**The purpose of this bulletin is to inform customers of a change in the outer gasket used for Fleetguard filters FF2200 and HF40003.**

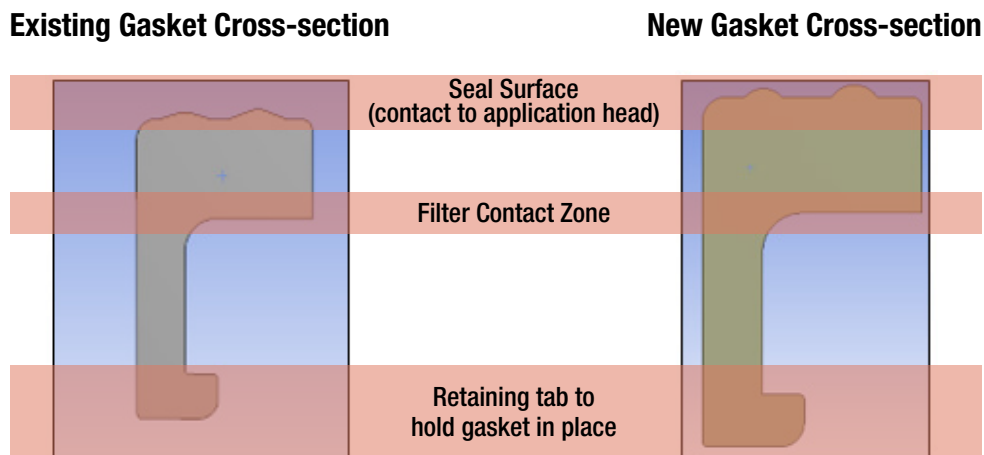
The outer gasket used to seal these two filters to their respective applications was modified for standardization purposes.

The new gasket profile is slightly thicker, taller and wider vs the existing gasket design. These features help increase the filter's hydrostatic pressure performance. A cross-section size comparison is shown in the table below:

The new gasket will be implemented on the FF2200 and HF40003 starting June 1, 2019 (Julian date code 152).
